Item **LPP01** - REPORTS - **7 June 2023**

ADDRESS/WARD: 13 Shellcove Road, Kurraba Point

APPLICATION No: 3/23

PROPOSAL: Alterations and additions to existing dwelling house and associated works.

Figure 13: Section 1

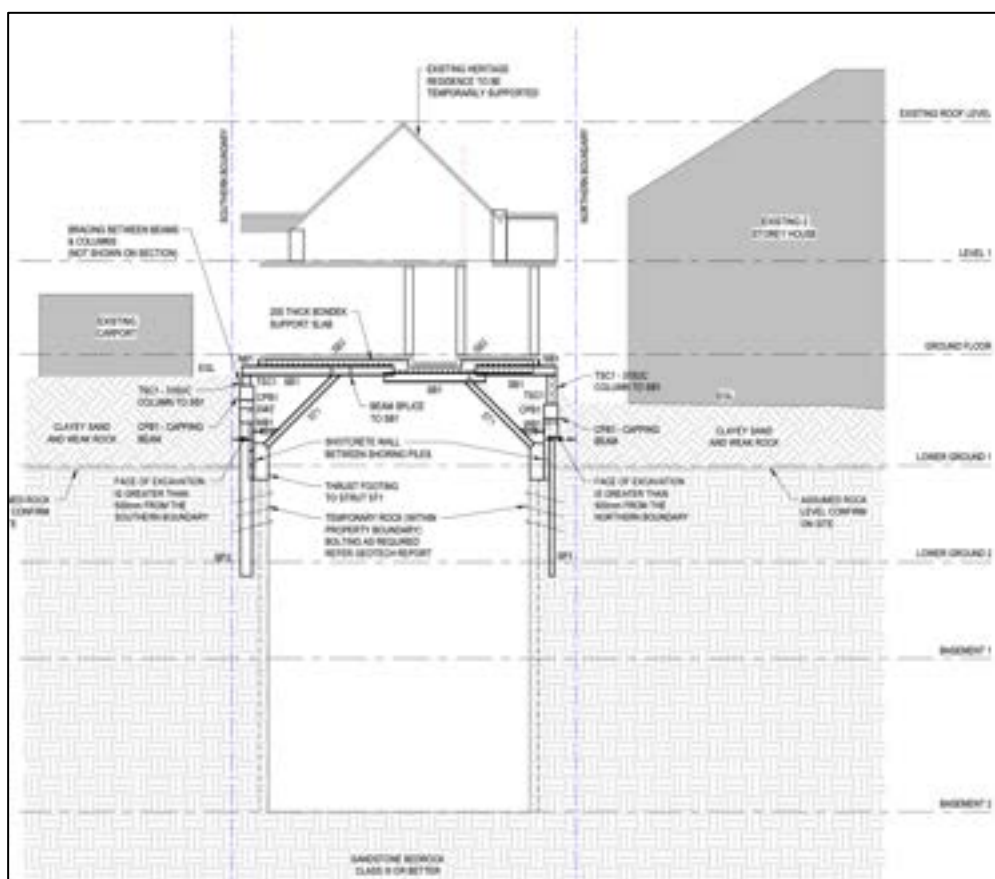
The proposed excavation under the existing heritage listed dwelling would necessitate temporary support. In this regard, the application is accompanied by a structural engineering report including an excavation and temporary building support plan – See **Figure 13**.

Concern is raised with respect to the proximity of the proposed steel piles and capping beam along the southern boundary being 200mm from the common boundary and 400mm for the heritage listed structures at No. 11 Shellcove Road.

The consent authority will need to be satisfied that the structural integrity of the subject heritage dwelling as well as the structures on the neighbouring heritage listed property will not be compromised by the proposed excavation (temporary or permanent).

Photo 13: View from Cremorne Point foreshore walkway

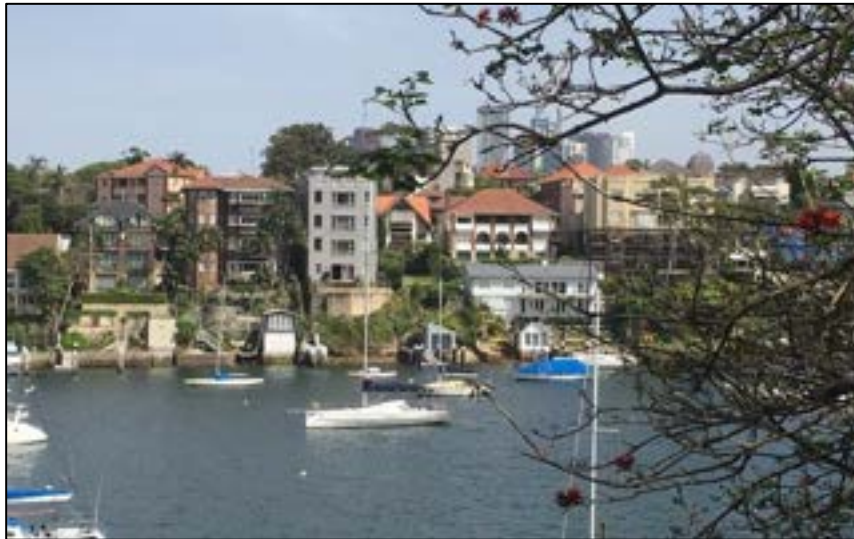
The subject site is highly visible from public vantage points (Cremorne Point foreshore walkway) and Shell Cove (refer to **Photos 13 & 14**).

Figure 14: Landscape Plan – Lower Ground floor 2

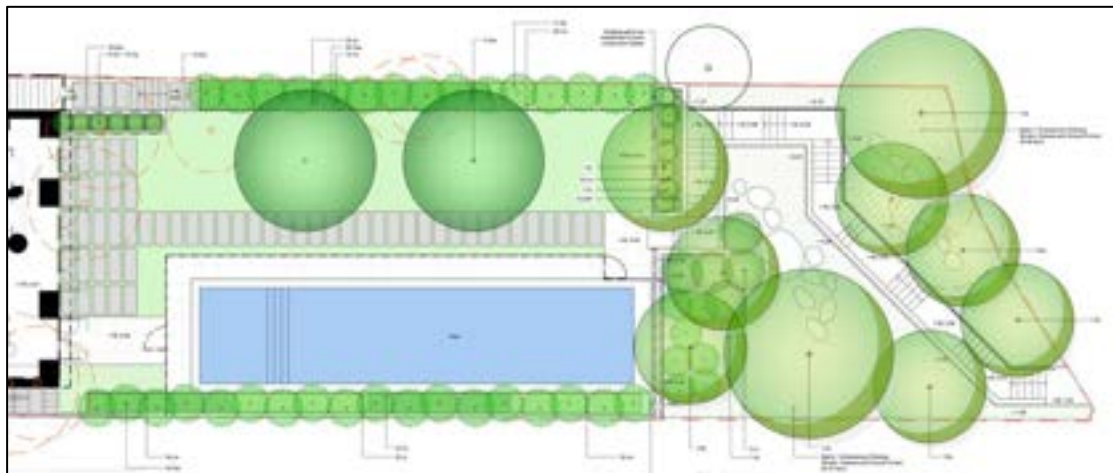
The applicant has not undertaken a view loss analysis and potential view loss is based on the spread and height of nominated trees on the landscape plans submitted with the application – see **Figure 14** below.

The proposed new planting along the northern boundary and within the foreshore area allows for a 11 new trees varying in height from 6m to 30m with a spread varying between 5m to 7m.

Figure 16: proposed 12 noon mid-winter shadow

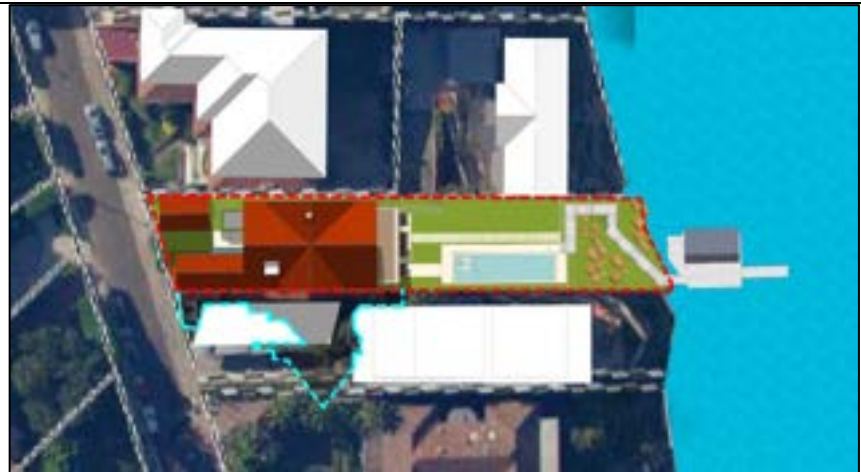
<p>1.3.7 Solar Access</p>	<p>Insufficient information</p>	<p>The application is accompanied by shadow diagrams in plan form only. However, additional shadow would occur on the northern elevation of No. 11 Shellcove Road. Unfortunately, no elevational shadows diagrams were submitted to demonstrate the extent of the proposed shadow effect on No. 11 Shellcove Road’s northern elevation.</p> <p>The additional shadows will affect apartments towards the western end of the northern elevation of No. 11 Shellcove Road.</p>
----------------------------------	---------------------------------	--

<p>the north western corner of No 11 Shellcove Road during the morning and afternoon period.</p> <p>Without elevation shadow diagrams the amount of solar access retained to the affected apartments cannot with accuracy be determine. The applicant failed to provide sufficient information to allow for an appropriate assessment under the relevant legislation.</p>								
1.3.10 Visual Privacy	Can be conditioned	<ul style="list-style-type: none"> • Lower Ground 2 Floor Plan Northern and southern elevation The proposed development does not introduce new windows on the northern or southern elevations, with the works being below EGL, with no opportunity for overlooking. Pool The new swimming pool is located 1.2m from the southern boundary. The finished coping level is at RL9.4 being 2.4m to 1.17m below existing ground level whilst the landscape plan proposes 18 Italian cypress along the southern boundary with a mature height of up to 12m minimising any opportunity for direct overlooking. • Lower Ground 1 floor Plan Northern and southern elevation The proposed development does not introduce new windows on the northern or southern elevations, with no opportunity for overlooking. • Ground level Northern elevation The new window within the northern elevation serves the stairs within the existing porch (in effect replacing the existing opening with glazing), with no adverse impact on privacy to No. 15A Shellcove Road. Southern elevation A new door (sunset lounge) and new bathroom window are proposed within ground floor level. The existing 1.8m high boundary fence obscures the new door and window and limits the potential for direct overlooking. <p>The rear addition includes a new green roof 800mm below the finished floor level of the ground floor. It is unclear if this roof is accessible. It does have the potential for overlooking so a condition to limit its use to a non-trafficable area can be imposed should the application be worthy of support.</p> <ul style="list-style-type: none"> • Level 1 There are no new windows or outdoor areas on this level. 								
1.4 Quality built form										
1.4.1 Context	No	The proposed development is considered to be inconsistent with the context of the Kurraba Point Conservation Area for the reasons provided within the Heritage assessment and throughout this report.								
1.4.3 Streetscape	Yes	The proposed works to the footpaths and kerbs are appropriate.								
1.4.5 Siting	Yes	The characteristic building orientation and siting is maintained. The heritage assessment raised no concern with the siting of the proposed development.								
1.4.6 Setbacks – Front Match the alignment of the primary façade of adjoining buildings	Yes	No change to existing.								
Setback – Side Ground floor (up to 4m) = 900mm 2nd storey (up to 7m) = 1.5m	No	<p>A DCP side boundary setback compliance table is provided below.</p> <table border="1" style="width: 100%; border-collapse: collapse;"> <thead> <tr> <th style="width: 25%;">Elevation</th> <th style="width: 25%;">Existing</th> <th style="width: 25%;">Proposed</th> <th style="width: 25%;">Comply</th> </tr> </thead> <tbody> <tr> <td> </td> <td> </td> <td> </td> <td> </td> </tr> </tbody> </table>	Elevation	Existing	Proposed	Comply				
Elevation	Existing	Proposed	Comply

Figure 18: Northern elevation

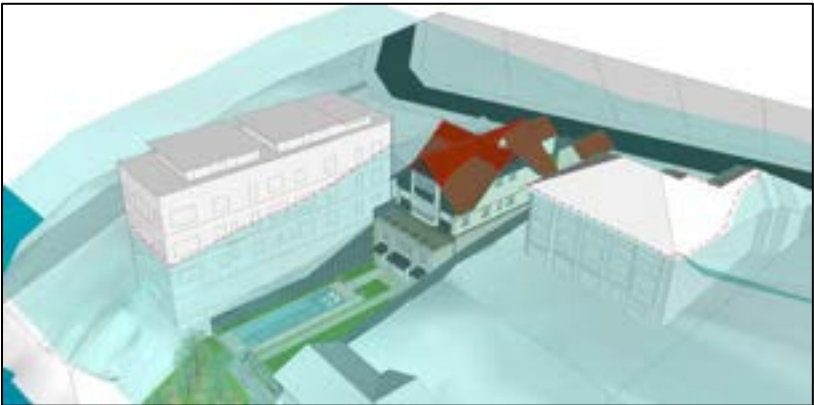
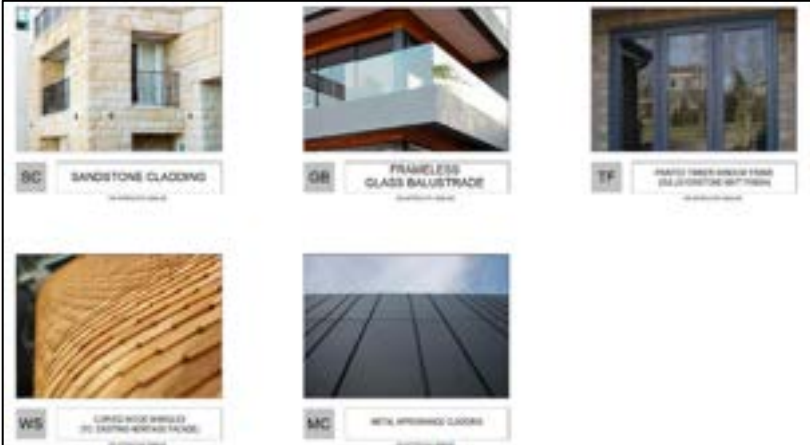
The built form above existing ground remains largely unchanged, however, due to the proposed excavation and rear extension, new wall planes and massing are created. The impact of which is most noticeable along the northern elevation (refer to **Figure 18** below).

The proposed built form follows the alignment of the existing building above resulting in a non-compliance with the side setback provision. The resultant bulk and scale are considered to dominate the heritage item and is not in keeping with the character of the Kurraba Point conservation area.

In summary, the proposed bulk and scale within the side setbacks results in a massing which dominates the heritage item contrary to Objective O2, in Part B, Section 1.4.6 Setbacks in NSDCP 2013.
